2. **Resolution No. 436 OrePac Site**

DB24-0001 OrePac Site Improvements

Exhibit A1  
Staff Report  
Wilsonville Planning Division  
OrePac Site Improvements  
Development Review Board Panel 'A'  
Quasi-Judicial Public Hearing

<b>Hearing Date:</b>	September 9, 2024
<b>Date of Report:</b>	August 29, 2024
<b>Application No.:</b>	DB24-0001 OrePac Site Improvements
<b>Request/Summary:</b>	The requests before the Development Review Board include a Zone Map Amendment, Stage 1 Preliminary Plan, Stage 2 Final Plan, Site Design Review, Lot Line Adjustment, Right-of-Way Vacation, and Type C Tree Plan.
<b>Location:</b>	30160 and 30170 SW OrePac Avenue, 30445 SW Boones Ferry Road, and 9655 SW 5th Street. The property is specifically known as Tax Lots 600, 680, 690, 700, 701, 780, and 791, Section 23B, and Tax Lots 101, 200, and 300, Section 23BD, Township 3 South, Range 1 West, Willamette Meridian, City of Wilsonville, Clackamas County, Oregon
<b>Owner/Applicant:</b>	Inland Pacific Properties LLC (Contact: Darin Coder)
<b>Authorized Representative:</b>	Mackenzie (Contact: Sid Hariharan Godt)
<b>Comprehensive Plan Designation:</b>	Industrial

Subsection 4.154 (.01) B. 1.

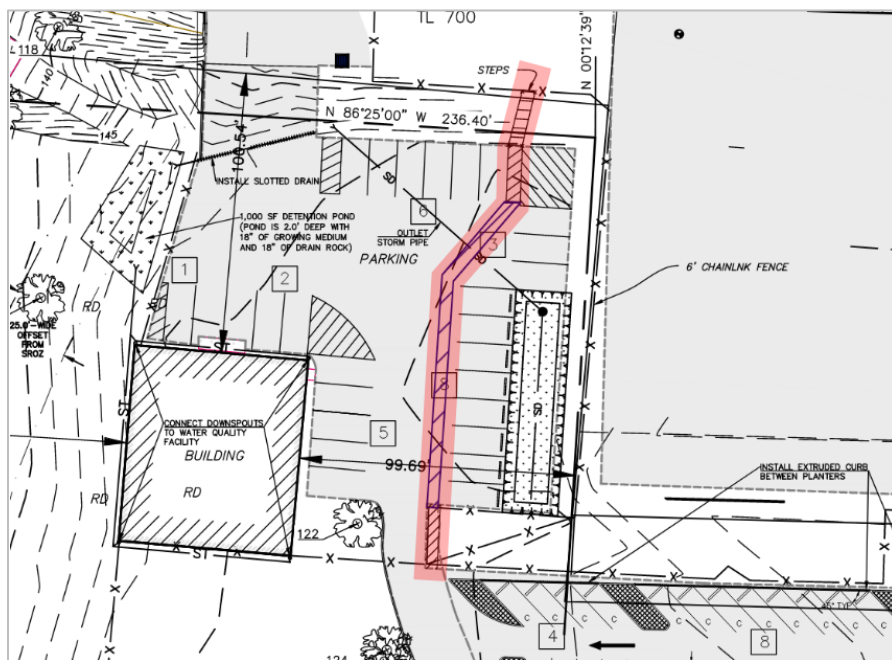
**C24.** As shown on the applicant's plans in Exhibit B2, no changes are proposed to the existing pedestrian pathway system (sidewalks) in the previously developed parts of the subject property. A striped pedestrian walkway is proposed in the new parking area, from the northwest corner of the south portion, north through the north portion, to provide access to a person door at the southwest corner of the building (Exhibit B4 and illustration below). Gates will be provided where fencing crosses the proposed walkway.

Per the applicant's narrative, based on discussion with City staff, a pedestrian connection to SW 5<sup>th</sup> Street, along the proposed new driveway, is not required or proposed given that the new driveway will be used for truck-trailer traffic and not passenger vehicle/pedestrian movement.

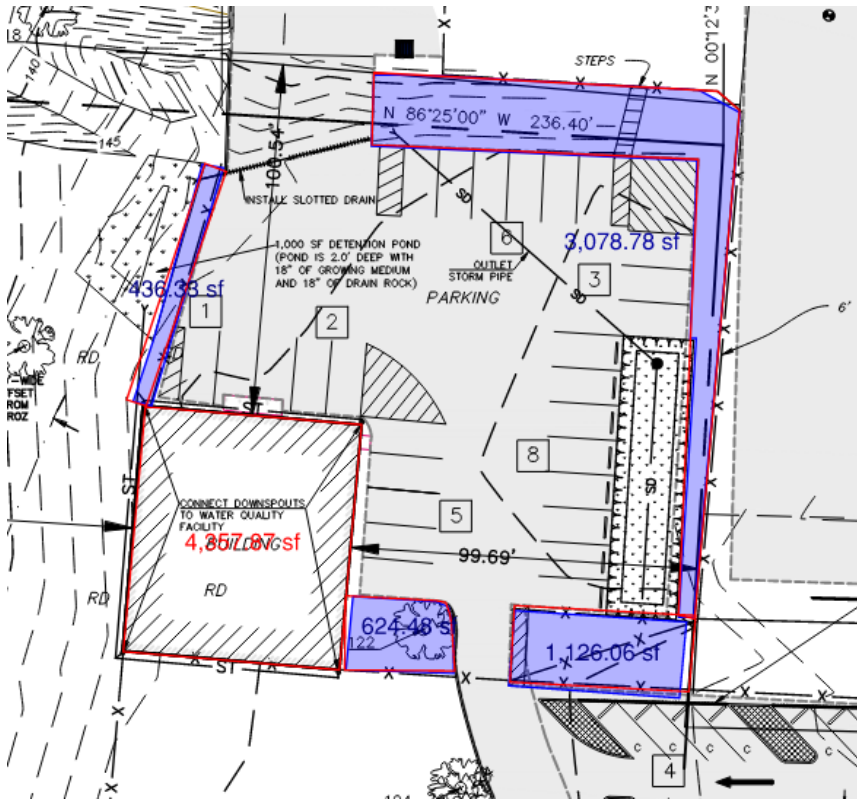
- Using the allowance from Table 5 for the Office and Warehouse uses, not including the small building above, results in the calculation in the table below. A total of 229 spaces are proposed (per Sheet C2), which is two over the allowed maximum. However, if some of the building area is considered manufacturing, which doesn't have a maximum, then there is no maximum for the site. On page 36 of the applicant's narrative it states "the Manufacturing use does not have a maximum parking ratio, per Table 5" – What part of the building is considered "Manufacturing"? I have a question out to OrePac on the manufacturing SF and will provide this number as soon as available. It does not appear that the building in the SW corner was considered in the SF calcs, for purposes of the parking min/max. With the addition of the building (Office use), the total office space is approximately 36,652, which provides for a maximum off-street parking space count of 150 ((36,152/1,000)\*4.1). This revised SF figure would raise the maximum to 245. I can revise the applicant's narrative to reflect this change, if that would be beneficial.

- Four motorcycle spaces are shown, not three, at the NE corner of the new southern parking area. This is consistent with the narrative (pg 37), but not with the calculation table on Sheet C2. Please clarify. [Four \(4\) motorcycle parking spaces are proposed. The plan Sheet C2 incorrectly shows three \(3\) in the parking table.](#)

- Parking Lot Landscaping – Section 4.155 (.03) B.: Why are there no landscape islands or landscaping proposed (Sheet L1.10) in the new northern parking area? Are existing trees along the north and east sides being considered parking lot landscaping? [That is correct, the areas in blue boxed in the image below are considered as landscape islands and are provided at an aggregate from the northern parking lot area. The impervious area of the L-shaped parking area is ~15,850 SF, and approximately ~5,200 SF of parking area landscaping is provided, satisfying the 10% requirement. These areas have mature trees which will provide shade to the parking area. Additionally, the new storm facility in the northern parking area is a vegetated facility that can provide similar landscaping qualities.](#)
